RECORD OF SIGNIFICANT FINDINGS and ACTION PLAN.

ADDRESS: Grenfell Tower, Grenfell Road, London W11 1TQ TMO Property reference number UPRN S217012770009

COMPLETED BY: Mr C Stokes

DATED: 26th April 2016

2nd Floor

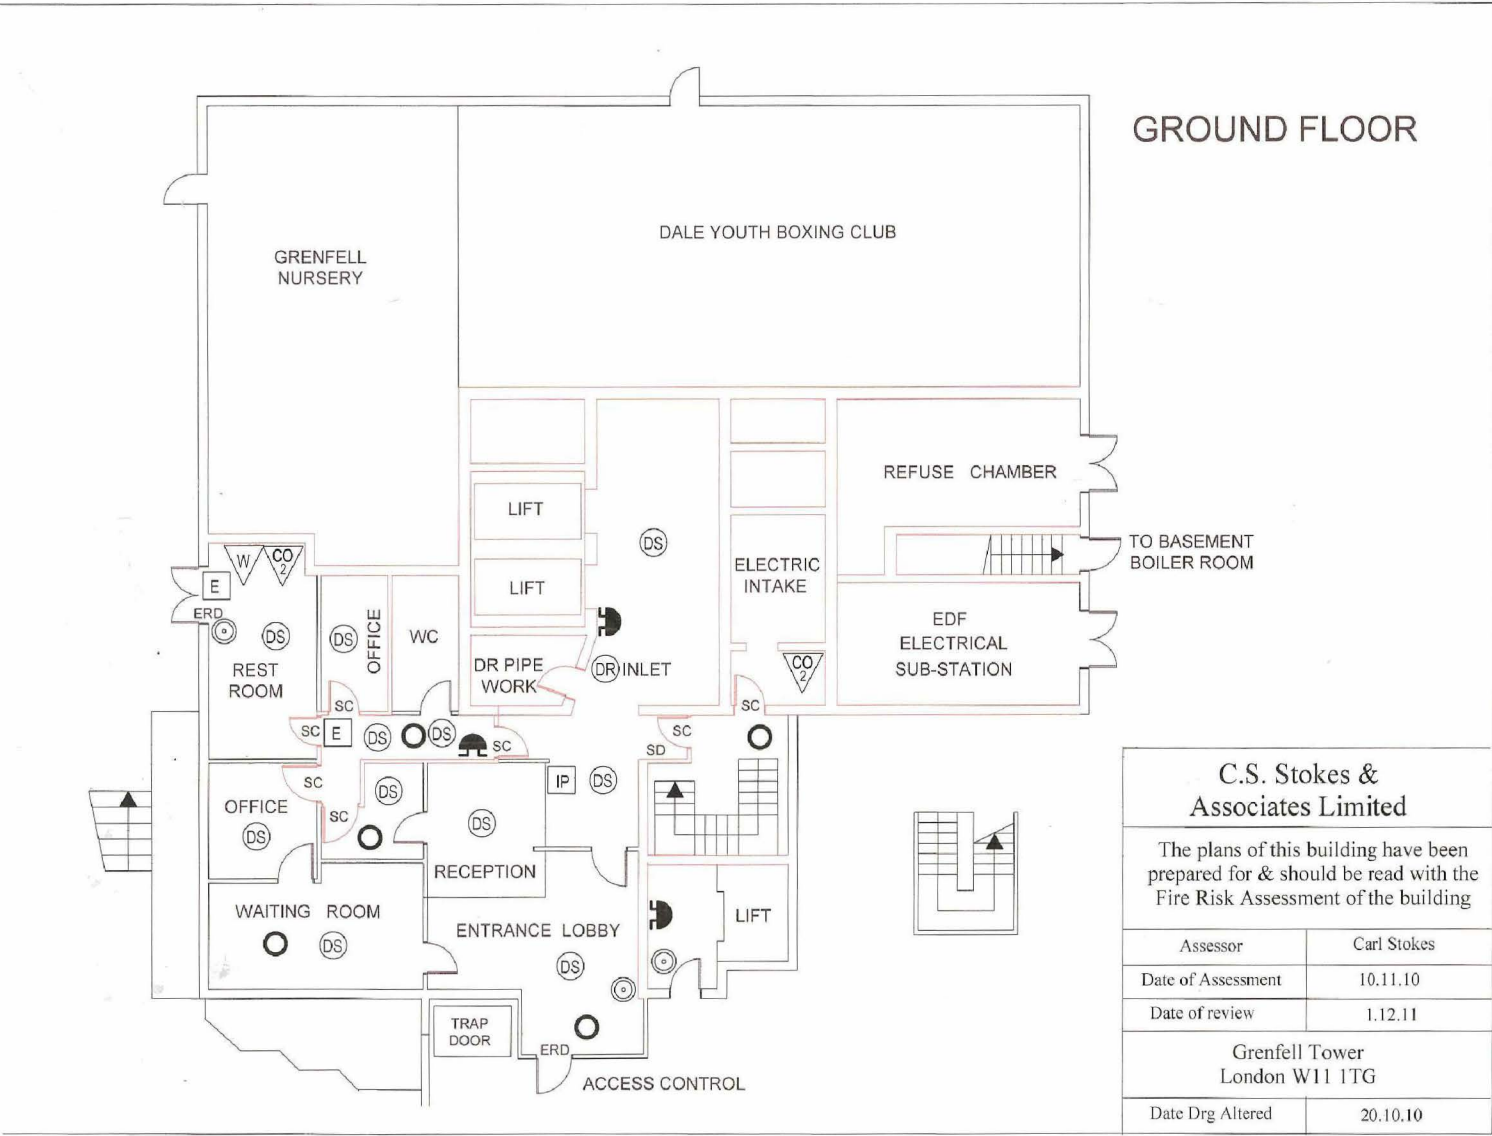
~~staircase door
10 = fire rated
damaged~~

~~New door 112
pose
not shield
A730~~

Roof Level

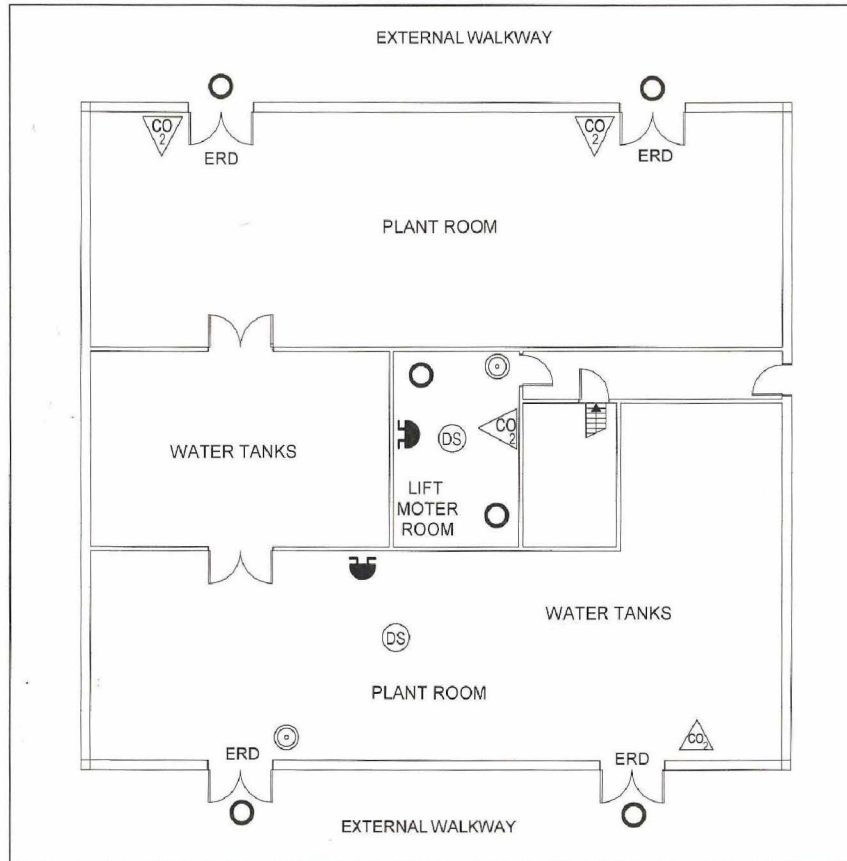
*Keep the
lighting
Electrical*
